## 4L60/65/70-E

### PRODUCTION CHANGES / INPUT SPEED SENSOR ADDED

## Technical Service Information

Figure 2

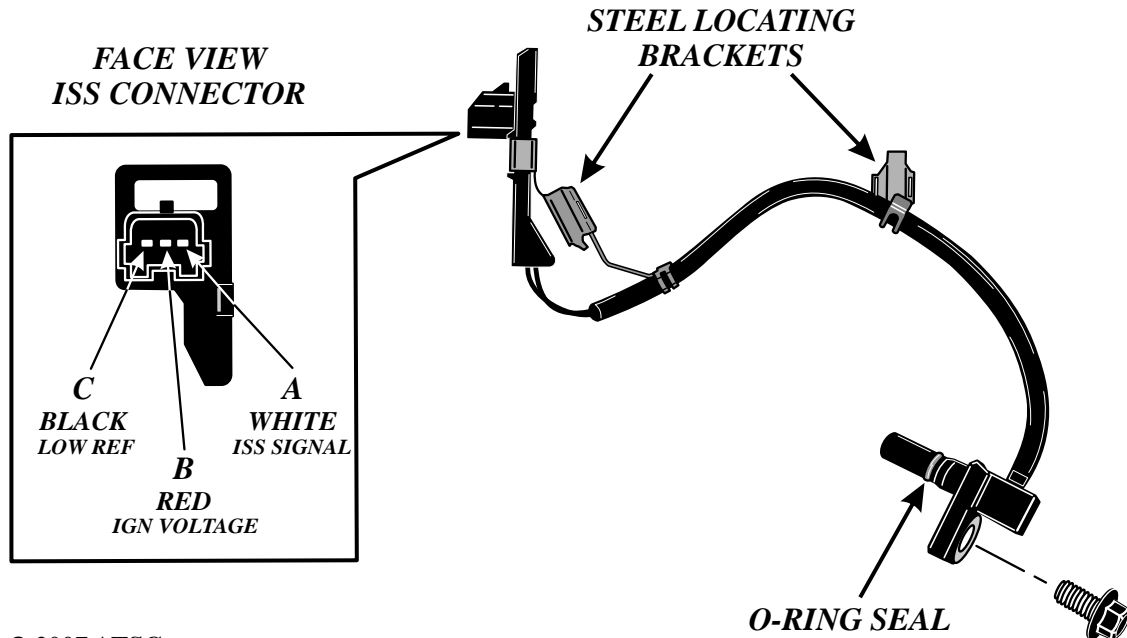
- CHANGE:** A new turbine input shaft speed sensor (ISS) has been added in some limited models beginning with the 2006 model year and expanded to additional platforms for 2007. (Refer to the chart in figure 1 for model usage)  
The ISS assembly is a three wire hall-effect sensor that is mounted internally to the oil pump assembly. (See figure 2)  
The ISS uses the rotor teeth located on the turbine input shaft to generate a digital voltage signal of varying frequency that corresponds to the rotational speed of the input shaft. (See figure 3)  
This also required the addition of a new internal wire harness assembly. (See figure 4)

**Input Speed Sensor** - The ISS assembly as shown in figure 2, is internal to the transmission. Operation of the ISS should be thoroughly evaluated with a scan tool to monitor RPM prior to transmission removal for any repairs. Due to the ISS circuitry design with its internal integrated circuit (IC) chip, it is not beneficial to measure the internal resistance and therefore no internal resistance values have been made available. Improper converter clutch operation or possible converter drain back concerns may be caused if the o-ring seal is damaged or omitted when servicing the ISS. The steel locating brackets are necessary to keep the ISS wiring from coming in contact with the rotating reverse input clutch housing. These brackets push fit on to aluminum bosses that are cast into the oil pump cover.  
At the time of this printing, the OEM part number for the ISS assembly is **24237866**.

Figure 3

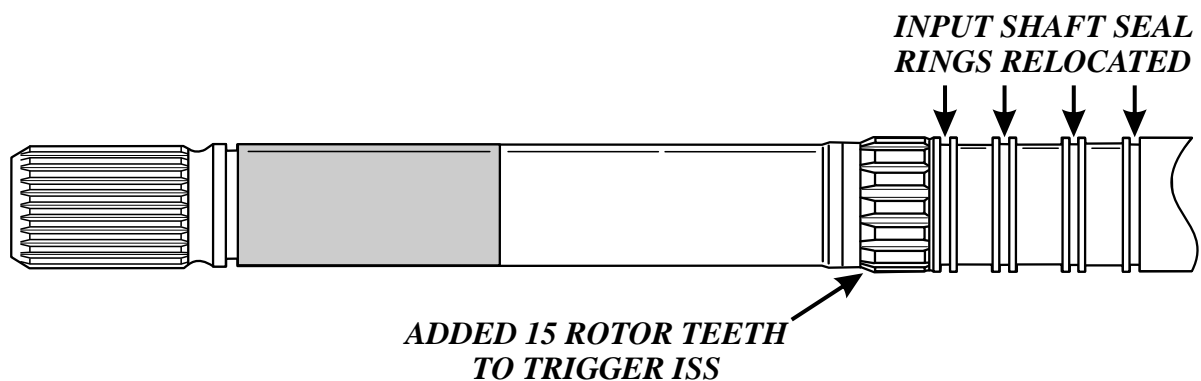
- CHANGE:** Oil pump cover changes also affected the stator shaft and stator shaft sleeve so as to relocate with oil passages within the oil pump cover.  
At the same time, the turbine shaft oil seal ring grooves were moved inboard towards the rear of the unit approximately 0.190”(in.) to create an area to manufacture 15 rotor teeth.
- REASON:** To correlate with changes in the stator shaft and sleeve assembly.
- CHANGE:** (4) Late in 2005 and early in the 2006 model year, some pre ISS models may still not have the ISS mounting holes machined into the cover. This will be evident as a smooth un-machined surface without the ISS mounting holes. As ISS models were introduced, the machining took place and the input speed sensor (ISS) was added. (See figure 8)  
For non ISS models, an ISS hole plug will be used in place of the ISS assembly.  
(See figure 9)

**Turbine Input Shaft** - The turbine input shaft as shown in figure 3 now has 15 rotor teeth added to trigger the ISS. The oil seal ring grooves have been relocated inboard towards the rear of the unit approximately 0.190”(in.) when compared to the previous design. Some pre ISS model turbine input shafts may have the rotor teeth machined in place and some may not. This was a manufacturing option. For this reason, great care must be taken when replacing the input clutch housing and turbine shaft assembly. A measurement from the front most oil seal ring groove to the base of the input shaft where it is pressed into the clutch housing must be taken and compared to the replacement component to ensure compatibility or transmission failure will be the result.

Figure 4

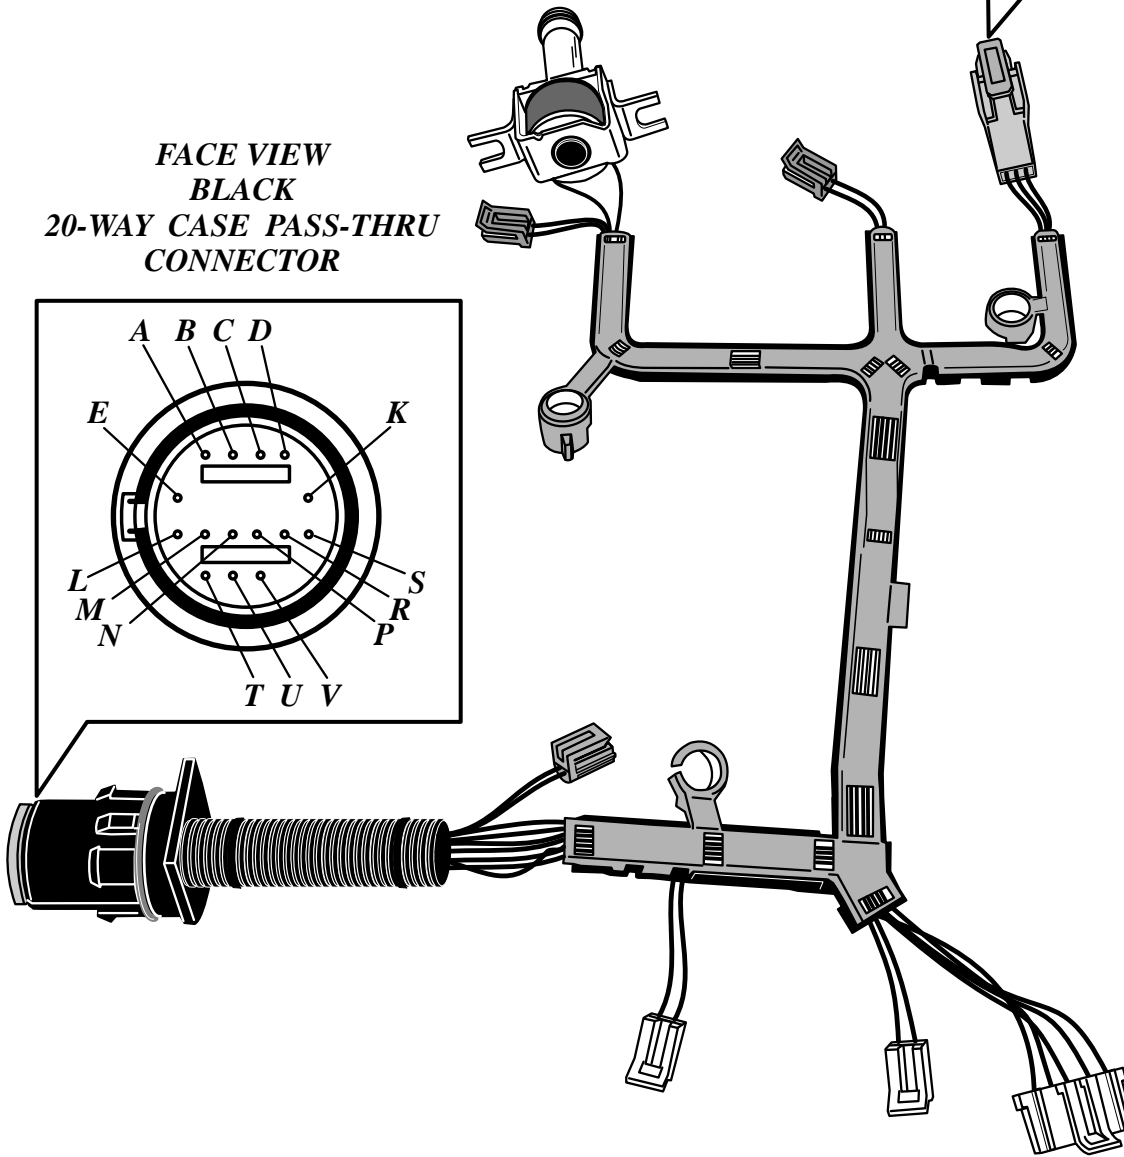
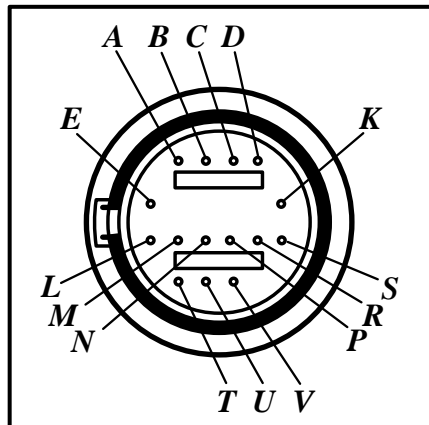
**Internal Wire Harness** - The internal wiring harness as shown in figure 4 contains additional circuits for ISS equipped transmissions and can be easily identified by the black 20-way pass-thru connector. Non ISS transmissions use the previous design harness which has a light grey connector. The ISS circuit shares pin position E (Ckt 839) for ignition feed voltage. This is a pre existing circuit and is spliced internally to supply power to the ISS. The additional pin terminals are K (Ckt 1230) for ISS signal and also V (Ckt 1231) for low reference.

At the time of this printing, the OEM part number for the new internal wire harness for ISS equipped transmissions is **24234121**.

Figure 5

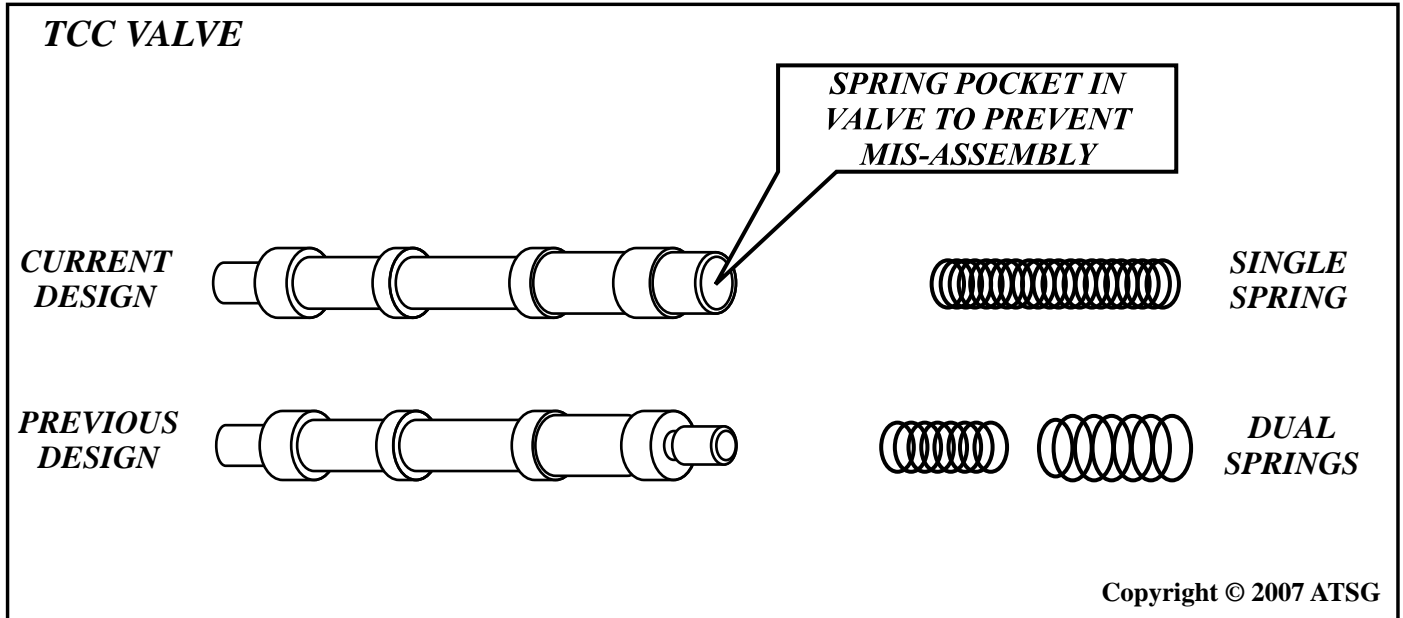
- CHANGE:** (1) Effective February 1st, 2005, the oil pump cover now uses a new design TCC valve with a single spring. (See figure 5)
- REASON:** Simplifies the assembly process, eliminates the possibility of springs becoming bound or bent and reduces material cost.

**TCC Valve** - The new design TCC valve uses a single spring and is shown along with the previous design level valve with dual springs in figure 5. The new valve incorporates a spring pocket to prevent incorrect installation by only allowing the spring to be assembled into the pocket end of the valve. Components of the previous and current designs may not be intermixed. However, the current design TCC valve and spring can be used to back service the previous design level.

Figure 6

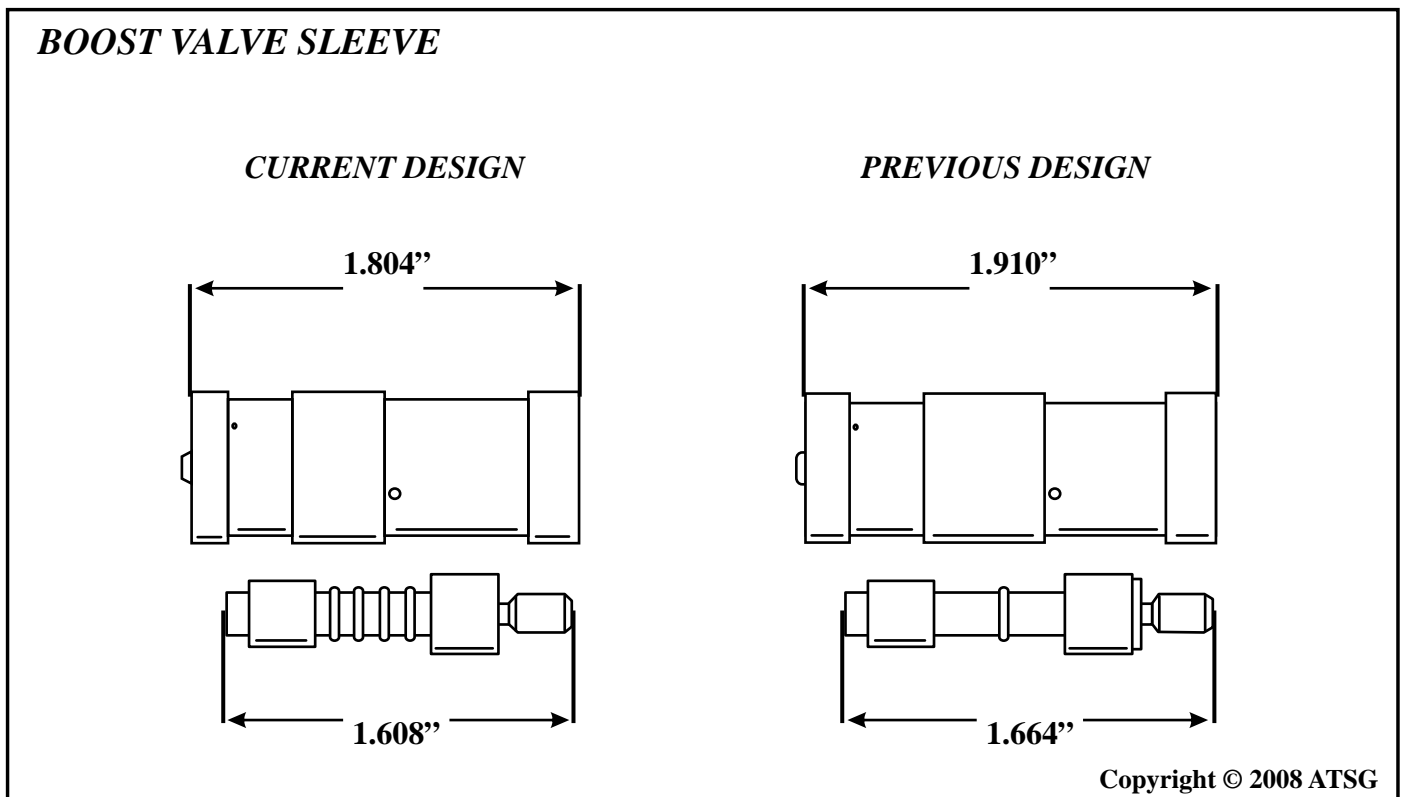
- CHANGE:** (2) Effective March 7th, 2005, the oil pump cover now uses a more compact boost valve and sleeve. (See figure 6) The snap ring groove location for the boost sleeve is now situated 2.57"(in.) from the bottom of the bore compared to 2.68"(in.) for the previous design. (Refer to figure 7) The bore length for the boost sleeve and snap ring has been reduced by 0.106"( in.).

**Boost Valve and Sleeve** - The boost sleeve as shown in figure 6 and its corresponding valve have been made shorter in overall length. No components of the current and previous designs may be intermixed, nor interchanged together as an assembly in place of the other. There are two versions of the current design boost valve and sleeve assembly with different valve land dimensions for standard and high performance use. The pressure regulator valve, pressure regulator valve spring and pressure regulator isolator spring remain the same as the previous design.

Figure 7

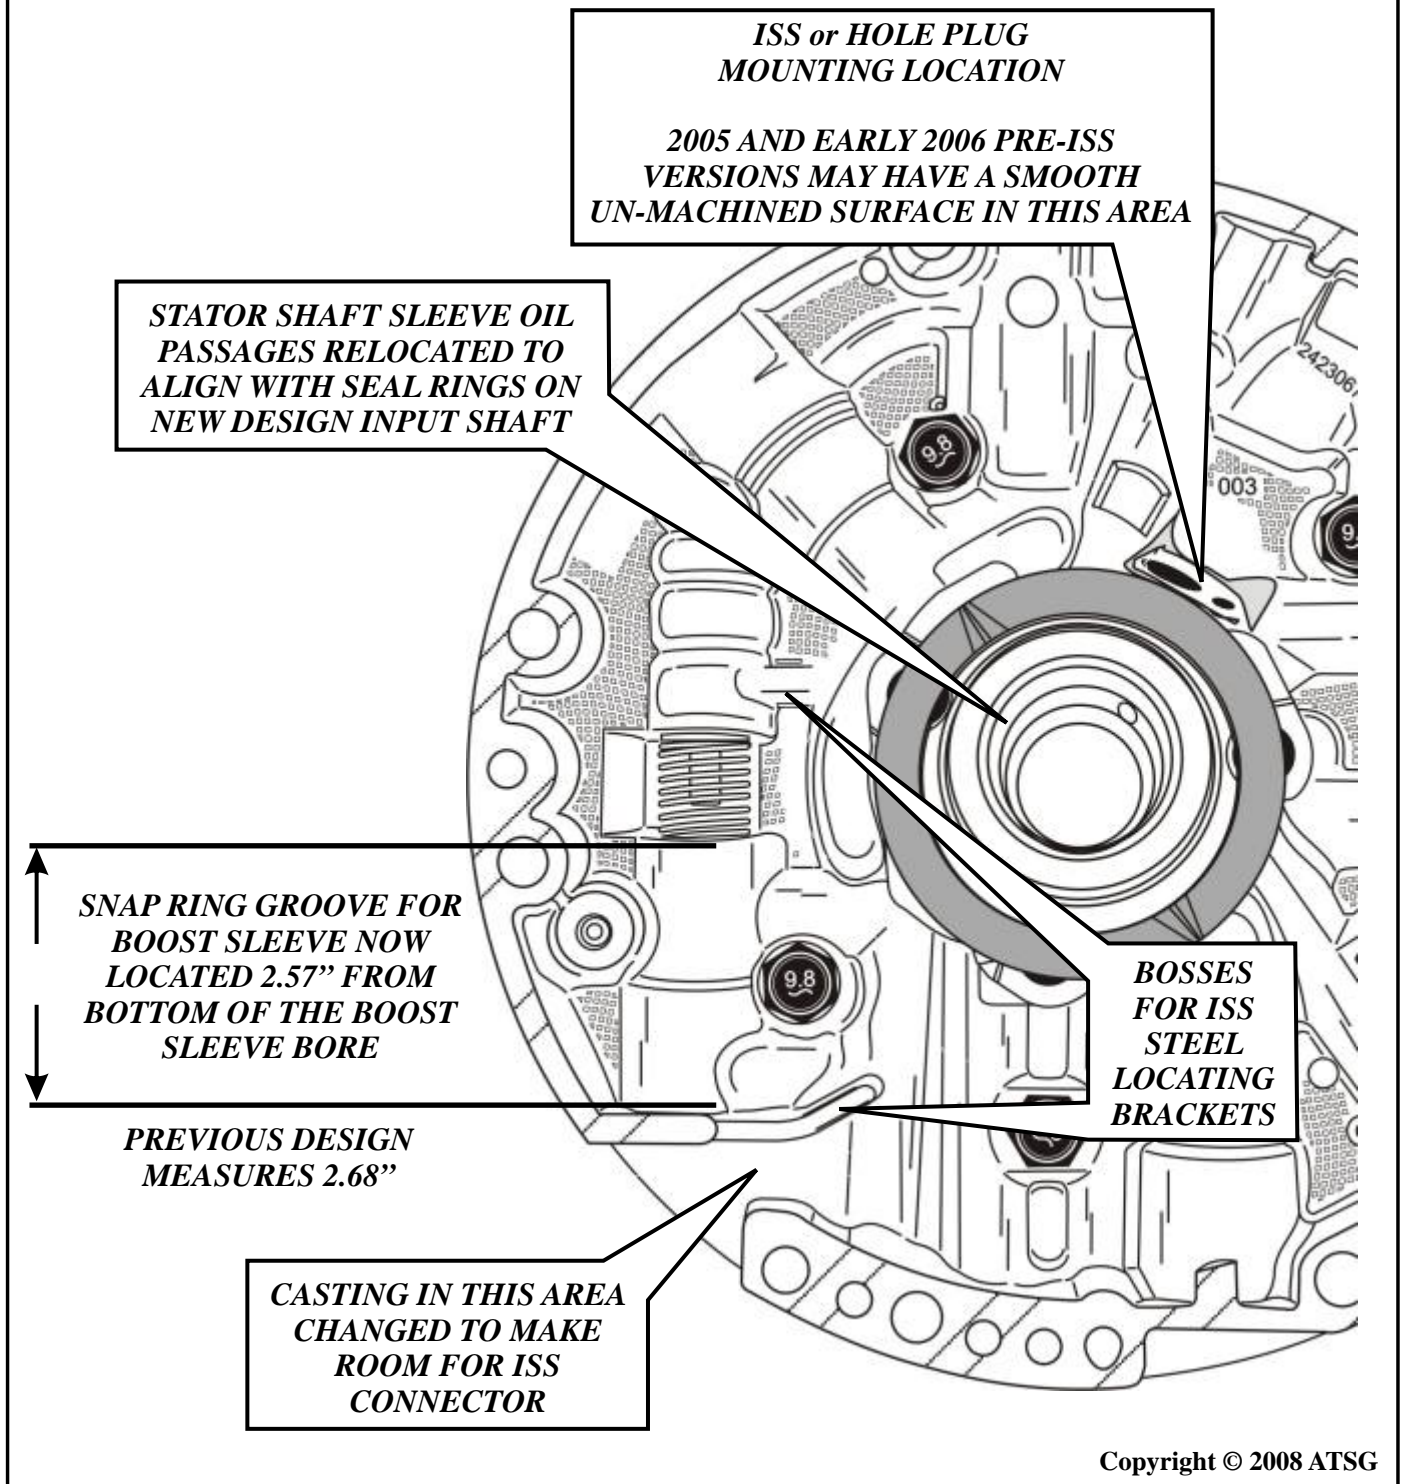
- REASON:** Necessary in order to prepare for the new input speed sensor (ISS) assembly that will be packaged into the pump cover.
- CHANGE:** (3) After July 16th, 2005, the pump cover casting was modified in order to situate the ISS connector. This modification removed metal directly below the PR valve and boost sleeve bore and extended a cast wall inward. The internal TCC release passage was also modified at this time. The ISS mounting holes are not yet machined into the oil pump cover. (This is shown in figure 7 also )

**Oil Pump Cover** - An outline of the oil pump cover and stator shaft changes can be seen in figure 7. Great care must be taken if the oil pump cover and/or stator shaft are to be replaced. This is due to the many changes in the oil pump cover casting and corresponding stator shaft sleeve oil passages. These pieces must be compatible with the turbine input shaft being used or transmission failure will be the result.

Figure 8

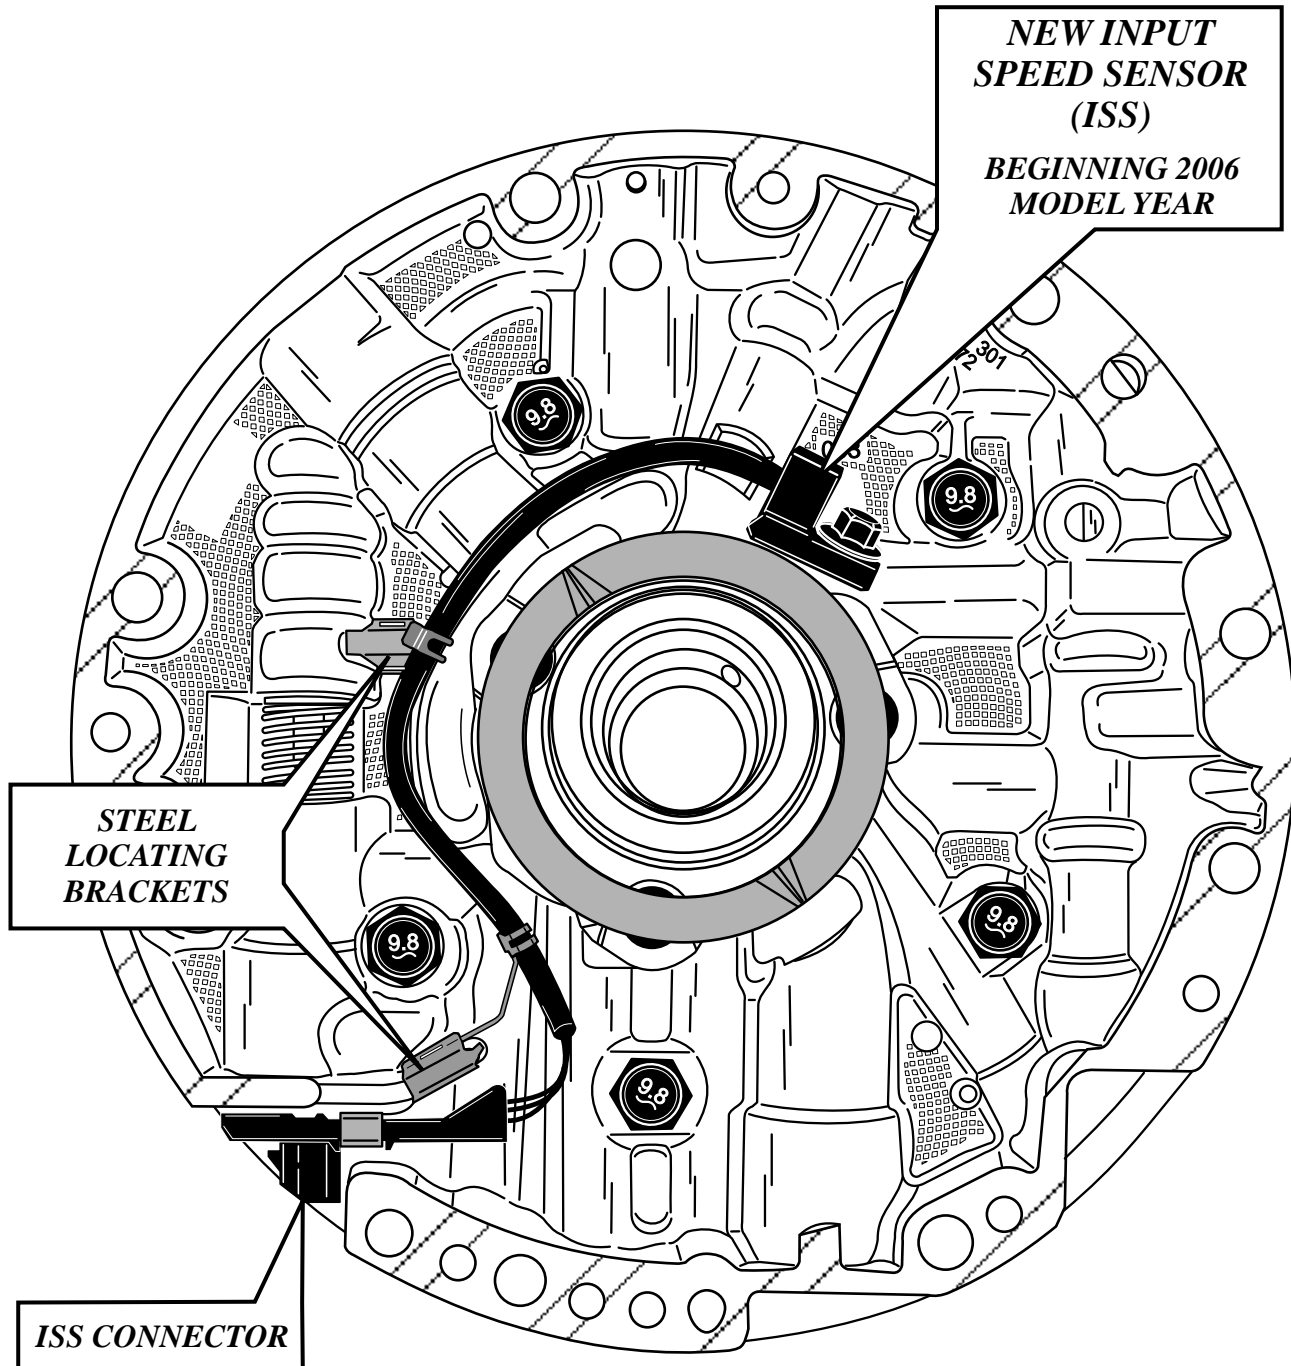
The boost sleeve and pressure regulator valve can not be serviced from the sump area on units equipped with an ISS because of the location of the ISS connector as shown in figure 8. This operation will require removal of the transmission and oil pump assembly. Pre ISS or non ISS models equipped with an ISS hole plug as seen in figure 9 will still allow access to the boost valve sleeve and pressure regulator valve from the sump. If the o-ring is damaged or omitted from the ISS hole plug then improper converter clutch operation or converter drain back concerns may be evident. Failure to install the ISS hole plug if required will result in low or no converter charge and no movement.
